GEORGIA APPALACHIAN TRAIL CLUB

September 7, 2019

Subject: Union County Target Range
Blue Ridge Ranger District

This is Georgia Appalachian Trail Club's letter of formal objection to the Finding of No Significant Impact decision on the proposed Union County Target Range Project draft Environmental Assessment.

223 REM 70gr Berger VLD

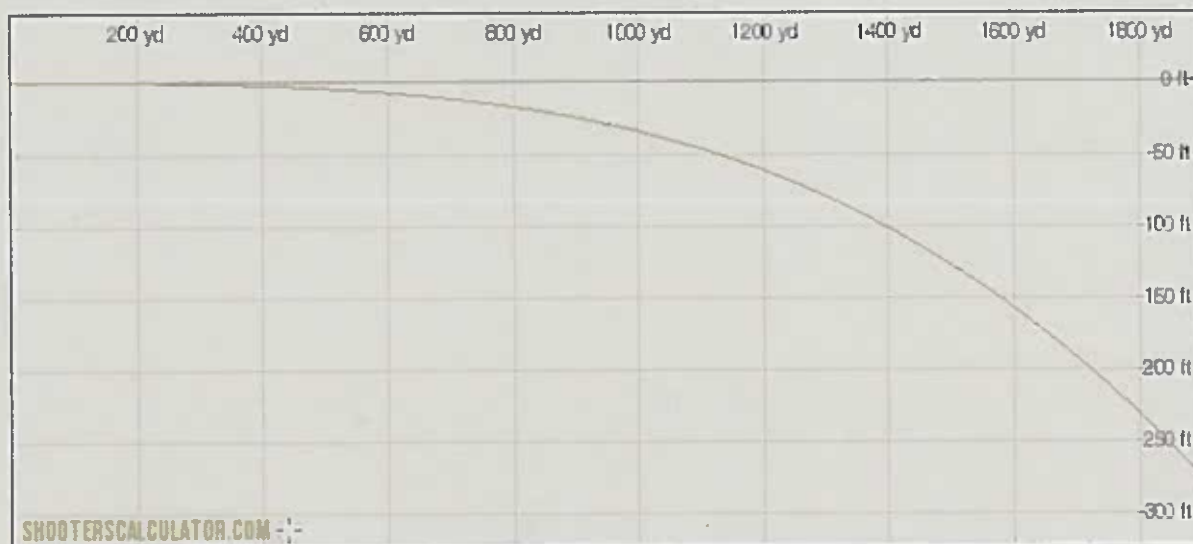
Using the same ballistics calculator, method and math, we conservatively estimate that a .223 caliber bullet fired from a rifle with the barrel elevated above horizontal about 13.6° would reach the area of Cold Springs Gap and the shoulder of Horse trough Mountain.

An online ballistics primer on a munition manufacturers website states, "...the shooter's primary reference in the field is the line of sight." On the proposed range, line of sight to the target line from the firing line is greater than 5° above the horizontal. That value can be subtracted from the elevation values in the above two paragraphs to determine that the perceived muzzle elevation for a round dangerously fired out is less than 10°!
